## TSB-89-6-6

1989 THUNDERBIRD

1989 COUGAR

Figure 1 - Article 89-6-6

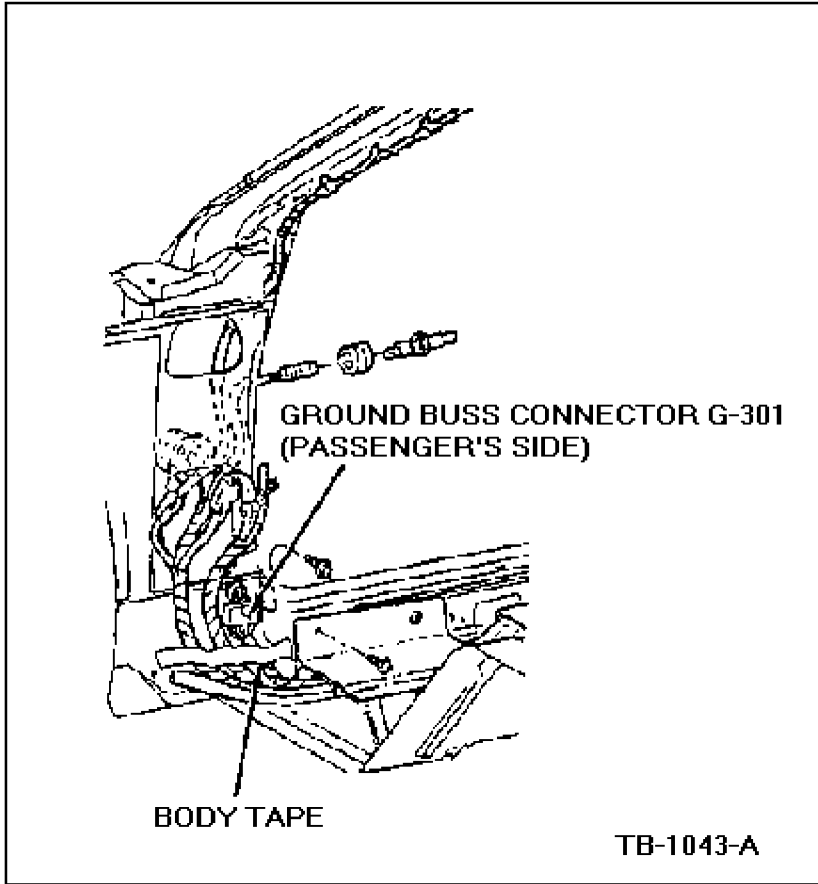
A no start condition or power accessories that do not work may be caused by a loose or disconnected wire at the ground buss connector. The wire leads from the ground buss connectors may be looped under the carpet at the lower edge of the cowl trim panel. This type of routing allows the occupants feet to apply enough downward pressure on the carpet to pull one or more ground terminals from the ground buss connector. Accessories and systems that could be affected are in the 1989 Electrical Vacuum Troubleshooting Manual (EVTM), pages 16 through 19. A partial list of these accessories and systems are:

Inspect the driver's side ground buss connector (G-300) and the passenger's side ground buss connector (G-301) for loose or disconnected ground wires. Refer to the following procedure for service details.

1. Using the 1989 Thunderbird/Cougar EVTm, pages 16 through 19, determine which ground buss connector (G-300 or G-301) requires service, Figures 1 and 2.

5. If a wire(s) is loose or pulled out of a terminal(s), remove the terminal(s) from the ground buss connector and solder the wire(s) to the terminal(s).
6. Re-install the repaired terminal(s) in the ground buss connector.
7. Reposition the ground buss connector. Rotate the ground buss connector either forward or rearward to allow the ground wire leads to be as close to the cowl as possible.
8. Install a 4-6 inch piece of body tape on the wire harness to hold it to the cowl panel, Figures 1 and 2.
9. Re-install the cowl trim panel.
